# Marple Area Committee

#### ITEM 1

Former Jasmine Thai Restaurant, Buxton Road, Hazel Grove, Stockport, SK7 6NA

Erection of 8 no. dwellinghouses with associated infrastructure and landscaping.

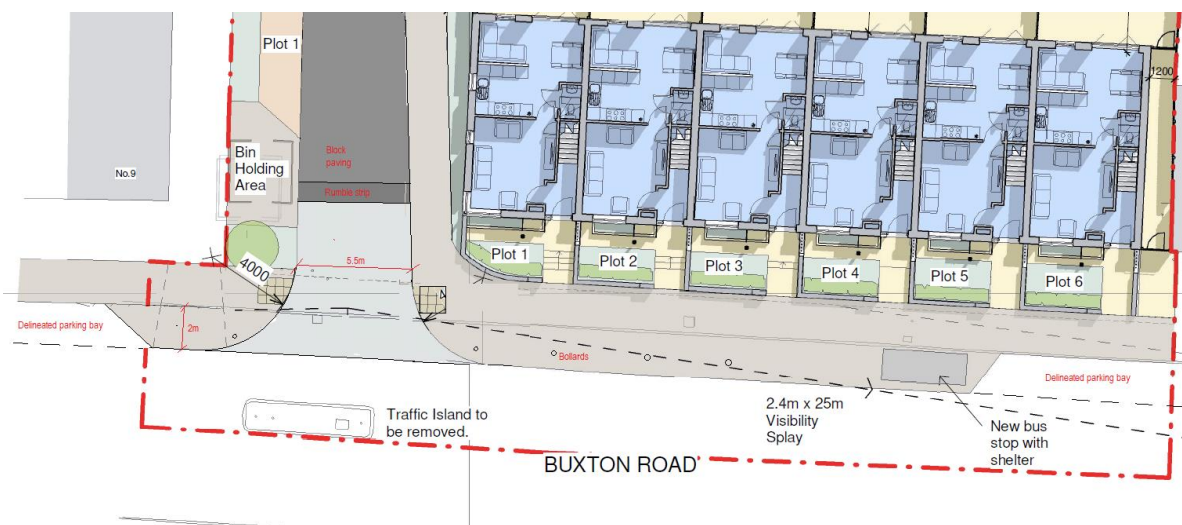
Whilst a cycle store is proposed to be provided, the layout / design of the store would mean that cycles could not be wheeled to / from the stands within the store. This issue, however, could be addressed by widening the store slightly and reconfiguring the stands, as shown on the drawing below.

Access to the cycle store will also be compromised due to the small gap between the spaces for Plots 3 and 5. This could be addressed by moving the space for Plot 3 so it is adjacent to the spaces for Plot 7 in order to provide a wider gap to access the store.

I therefore recommend that the application is also deferred to allow the applicant to submit a revised drawing to deal with these issues.
